Submissions on proposed housing in NW Bicester

[21/04275/OUT](#)

21 February 2022

Schematic 'simultaneous green' signalised crossing design and Bucknell Road connection (dark green = verge, salmon = cycle path, light green = footpath)

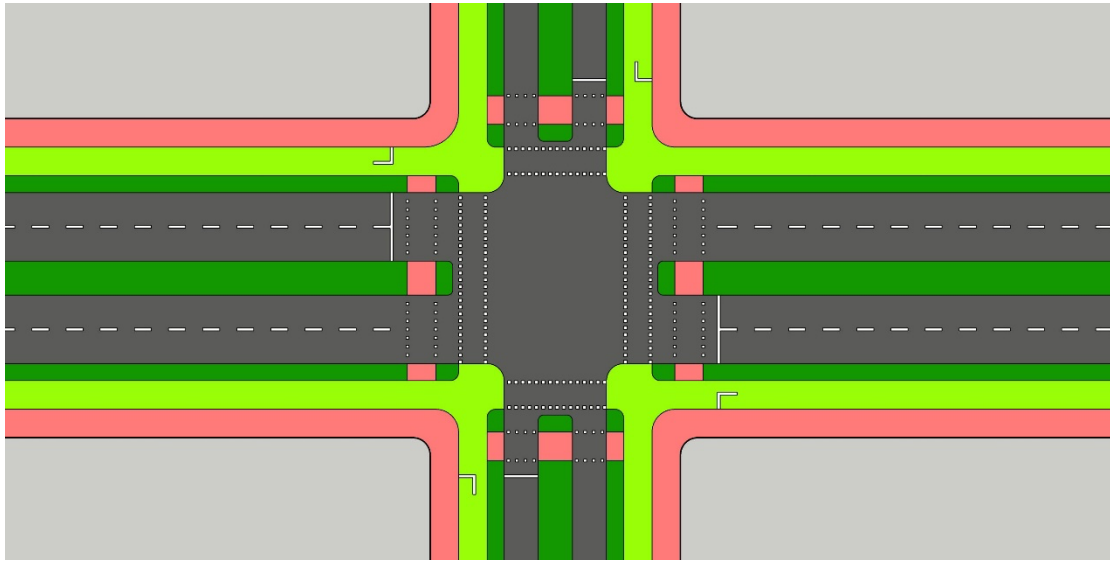
The proposed signalised crossing (File Ref 20300_SK_T_001(P3).pdf, Drawing Reference 20300 No 001) shows a legacy design that would not be suitable as an active travel junction. The shared path access routes and double stage signalised crossings are not in keeping with the level of ease of movement required.

Key points for the ‘simultaneous green’ are that there is a single phase for walking and cycling where all traffic flows are held, followed by two motor vehicle phases. Capacity can be adapted as appropriate depending on need by interposing the simultaneous green between each motor vehicle phase, or skipping it entirely if there is no demand. Cyclists remain on the paths closest to the traffic at all times.

A schematic is shown on the following page. The design can be scaled with any number of lanes of traffic.

The proposed cycling and walking connection using what is the current Bucknell Road is a welcome addition. It is worth noting that the cycle provision on Bucknell Road south of the indicated crossing is poor and well below current standards (<1m wide painted cycle paths for some sections) and the pavements are narrow. For the connection in the drawing to be usable to access Bicester facilities then Bucknell Road needs also be improved and brought up to LTN1/20 standards with segregated provision, buffers, and priority.

A more straightforward Dutch style ‘simultaneous Green’ junction, as recently implemented at various locations in Walthamstow, London would be a much better solution. See for example:

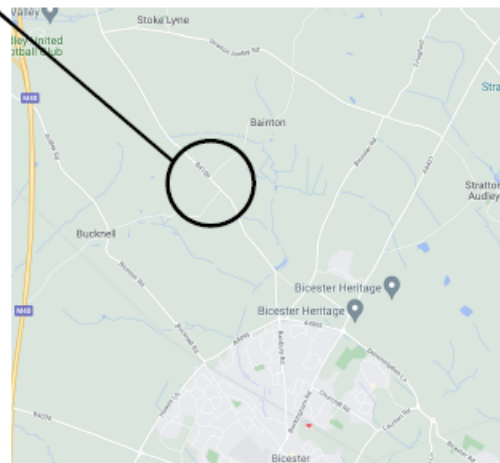
Filtered permeability is not systematically integrated into the existing plans, with the notable exception of the Bucknell Road connection. Links that prioritise pedestrian, cycle, and public transport movement over private cars need to be provided, for example to connect to the Elmsbrook exemplar site and the Firethorn development site.
